# 1963 - 1964 Corvette: Service News: Air Conditioning Changes

**Subject:** Air Conditioning Changes

**Model and Year:** 1963 - 1964 Corvette

**Source:** Chevrolet Service News

*Fig. 1—Rework of Blower Motor Circuit*

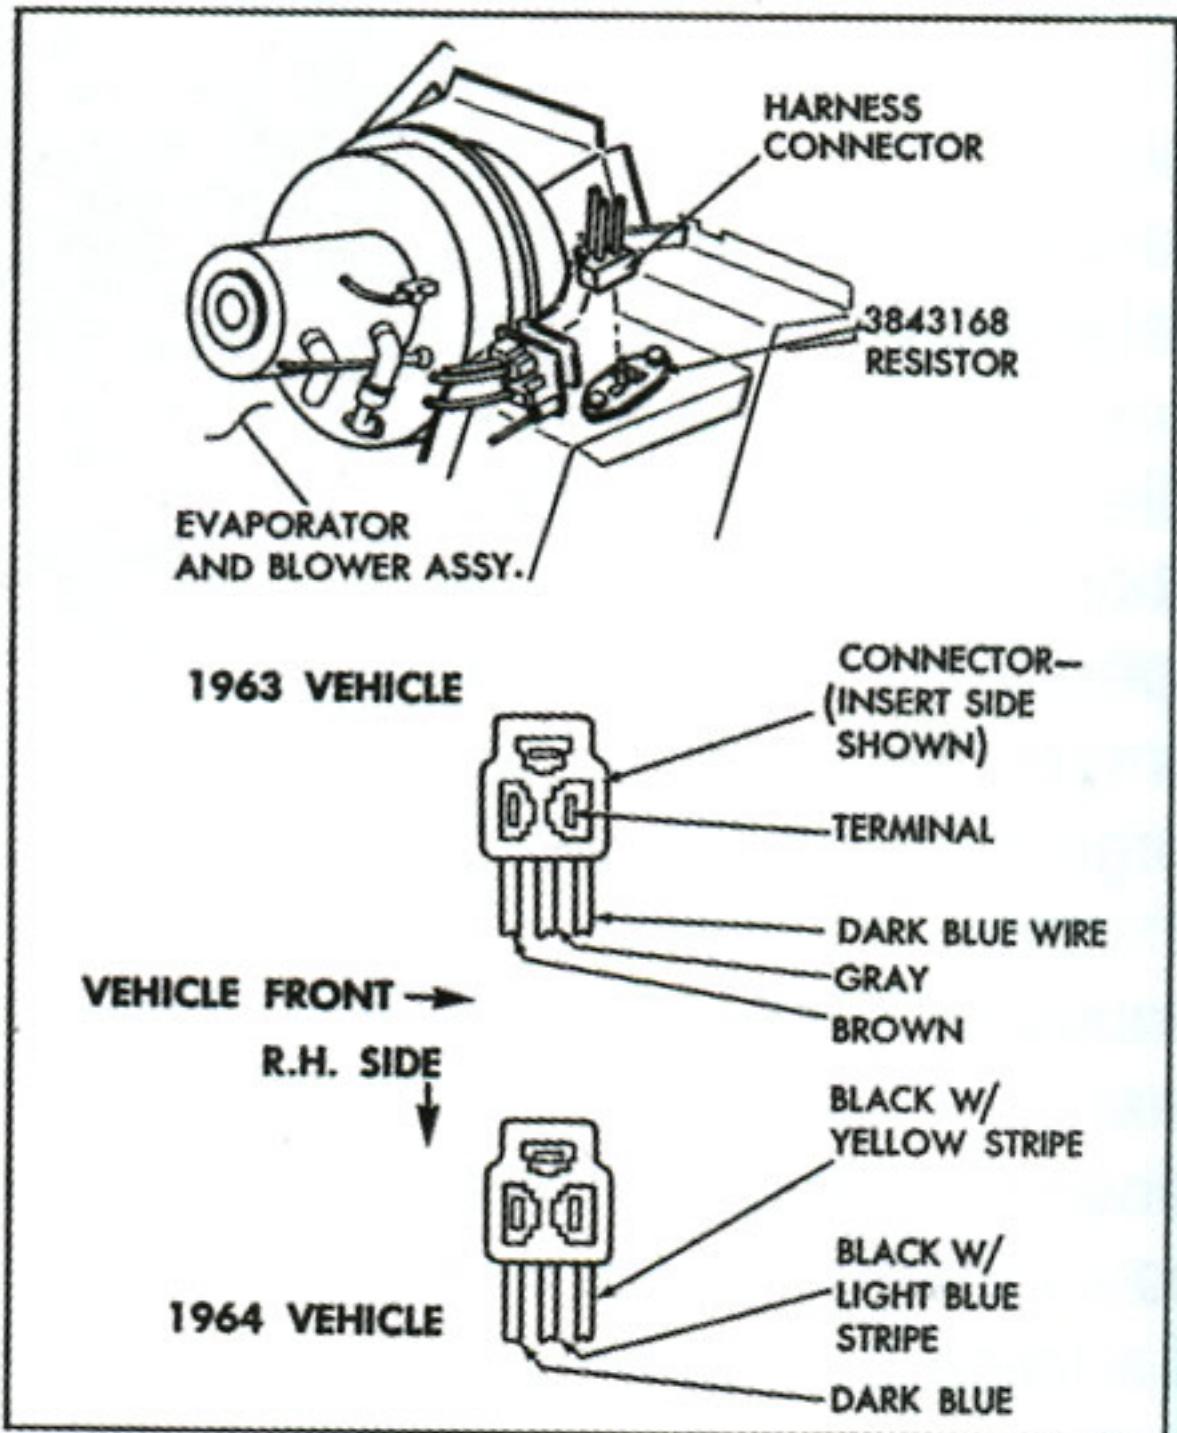
On all 1963 and early 1964 Corvettes equipped with Air Conditioner RPO C60, it would be necessary to slightly modify the electrical circuit to provide a true medium blower speed for the heater. In these RPO C60 installations, the resistor that was used in the blower motor circuit to establish blower medium and low speeds, unfortunately, during heater operation provides blower "low" RPM at the MEDIUM as well as at the LOW speed setting of the operator's control lever.

A wiring change introduced in Production averted the above problem on vehicles built later than December 16, 1963.

To provide the desired medium blower speed, on the earlier production units, proceed as follows:

1. Replace the installed blower motor resistor with Resistor Part No. 3843168.
2. Reverse the location of two leads in the multiple connector that plugs into the blower motor resistor assembly; reinstalling the color coded leads in the connector body at the locations show in Fig. 1.

**NOTE:** To remove the terminals from the connector body, insert a small screwdriver along the inboard side of the terminal and move the end of the screwdriver outboard to disengage the terminal from the locking ledge in the connector. Before reinstalling the terminals in the connector, spread the

terminals to insure that they lock securely when installed.
